802.3dj D1.4 Comment Resolution Logic Track

Introduction

- This slide package was assembled by the 802.3dj editorial team to provide background and detailed resolutions to aid in comment resolution.
- Specifically, these slides are for the logic track comments

Table 172-4—PCS stateless decoder rules

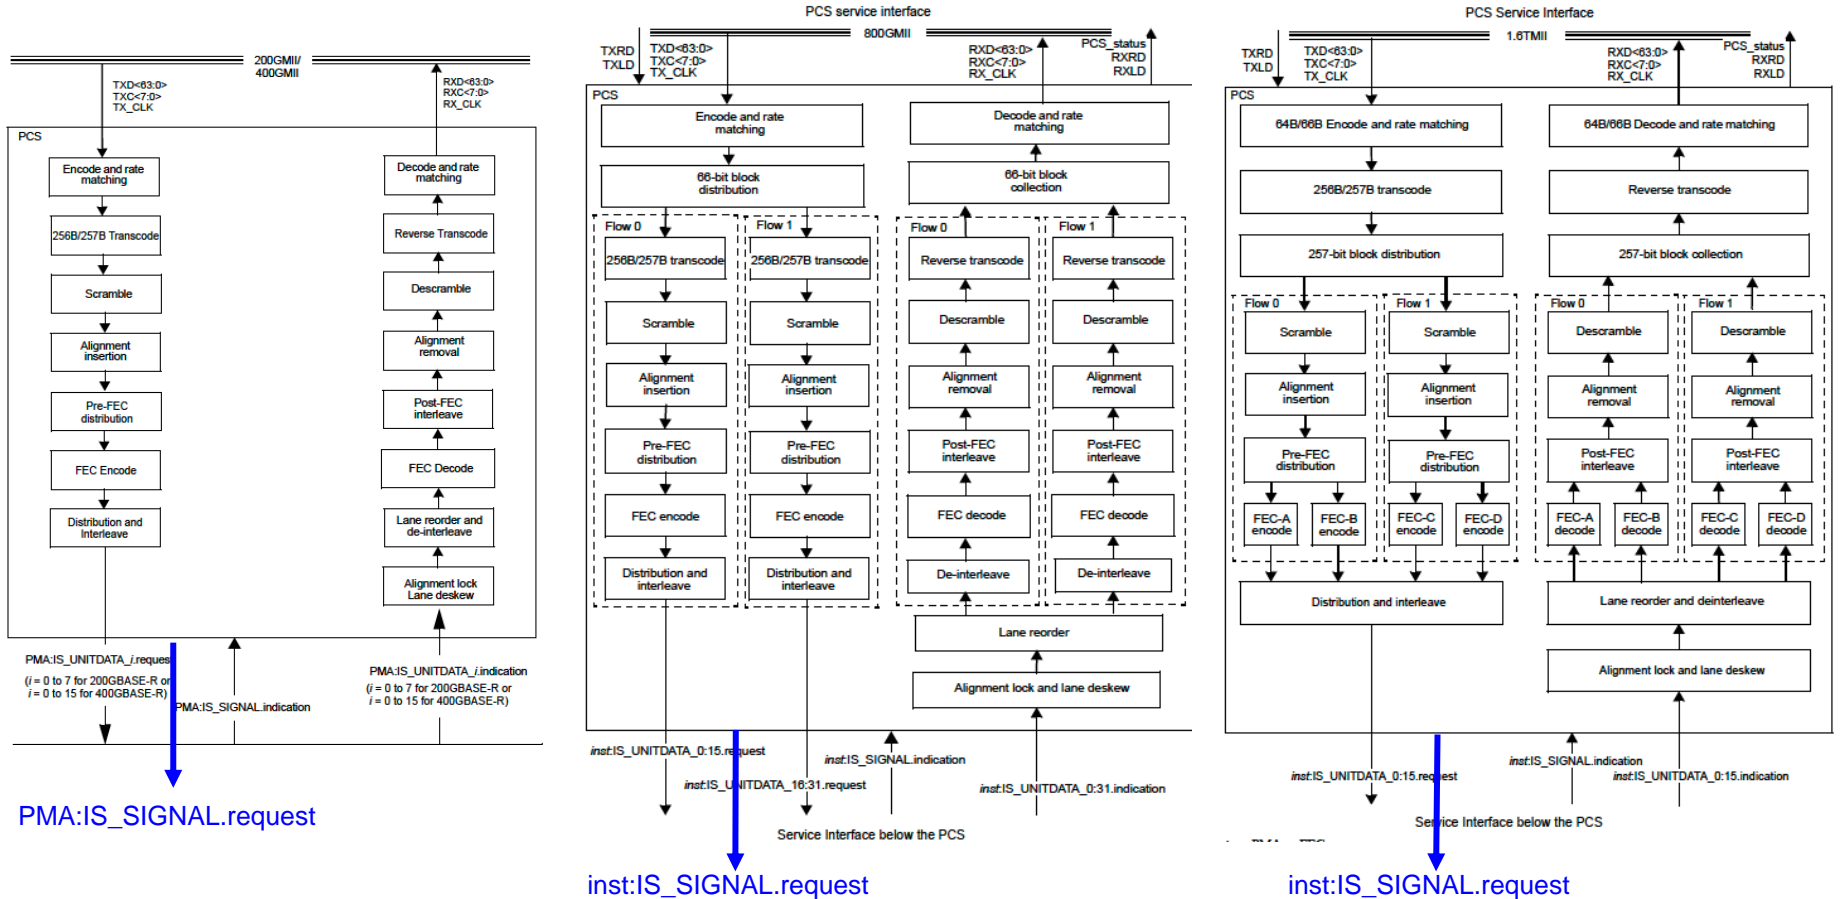
The stateless decoder assumes that the received data represent valid Ethernet data and does not check it for valid frame structure, unlike the State-diagram decoder.

This should be emphasized for readers familiar with the original decoder defined in Clause 119 to prevent surprises. For example, validation suites may check the PCS with data that is not valid Ethernet and expect it to reject it.

The suggested remedy applies to this subclause (119.2.5.8.2) and to 175.2.5.9. It should also apply to 172.2.5.9.2, but it is currently not in the draft and may be out of scope.

Add a NOTE at the end of 119.2.5.8.2:

NOTE—The stateless decoder relies on the Reed-Solomon decoder for error correction and marking, and unlike the state-diagram decoder, it does not check the validity of Ethernet frames.

PROPOSED ACCEPT IN PRINCIPLE.

The stateless PCS decoder is defined in CL 172 and there are references to it from CL 119 and CL 175. The best place for this note would be in CL 172 with the decoder definition itself, and then notes in 119 and 175 should not be necessary.

"NOTE- The stateless decoder does not detect all packet framing errors that the state-diagram decoder can detect. It relies on the RS FEC decoder for error correction and marking as well as the MAC ethernet frame FCS check for frame reliability."

Add note after table 172-4.

Table 176-6—*inst:IS_SIGNAL.request(SIGNAL_OK)* generation

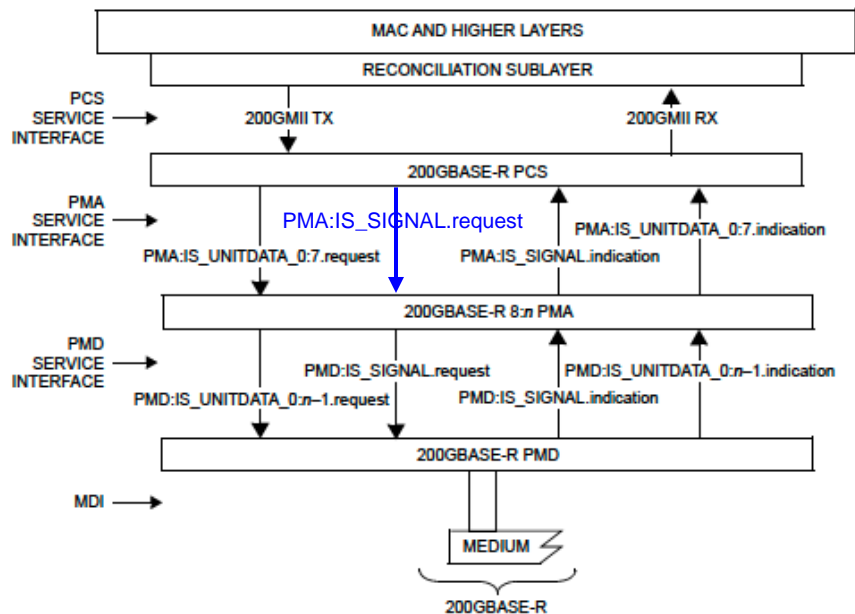
Comment #251 - PMA IS_SIGNAL Generation

PMA:IS_SIGNAL.request (from the sublayer above the PMA) can come from:

- Another PMA
- AUI
- PCS (newly added input)
- DTE XS (newly added input)

inst:IS_SIGNAL.request generation is more clear and consistent.

Figure 174-3—Inter-sublayer service interfaces for a 1.6TBASE-R PHY and 1.6TMII Extender

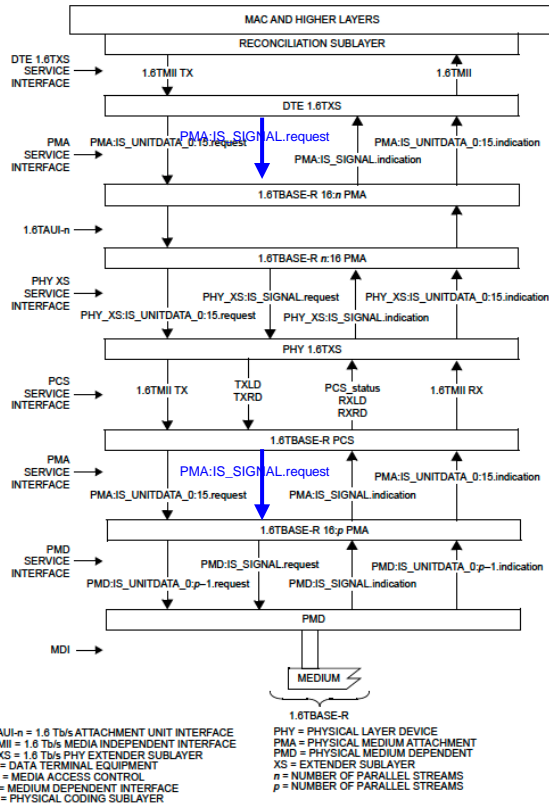
Fig. 174-3 Is a typical xBASE-R PHY with extender (Copper/IMDD PHYs).

- IS_SIGNAL.request added to both DTE and PCS Tx outputs

Figure 177-4—Convolutional interleaver

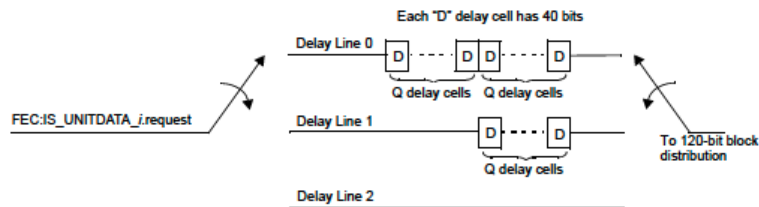
The relationship between the position of the input and output switches in Figure 177-4 is not defined.

Add the following sentence at the end of the paragraph: "The input and output switches are always aligned to the same row."

PROPOSED REJECT.

It is not required to keep the input and output switches aligned to the same row.

Change response to comment #47 for 177.4.2
From: REJECT
To: ACCEPT IN PRINCIPLE
Implement the suggested remedy with editorial license.

Figure 184-4—Convolutional interleaver

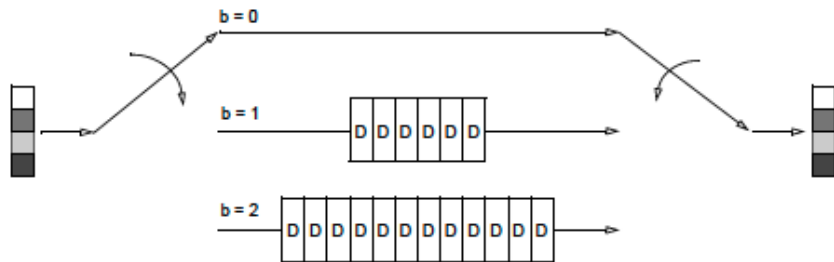
Part (a) Input and Output switches are always aligned to the same row.

It is a necessary part of the logical description of the CI functionality.

Figure 186-16—800GBASE-ER1 PMA FAW field lock state diagram

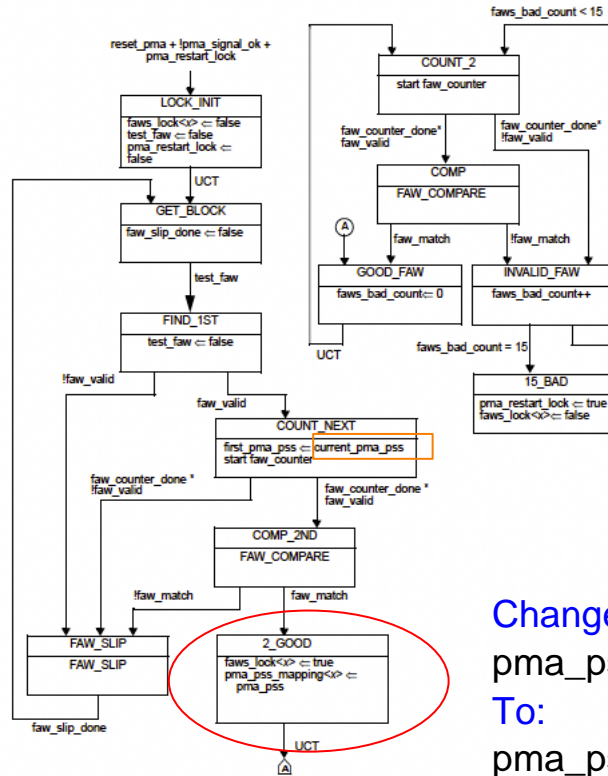
Comment #69 - Figure 186-16

Change from:

`pma_pss_mapping<x> <- pma_pss`

To:

`pma_pss_mapping<x> <- current_pma_pss`
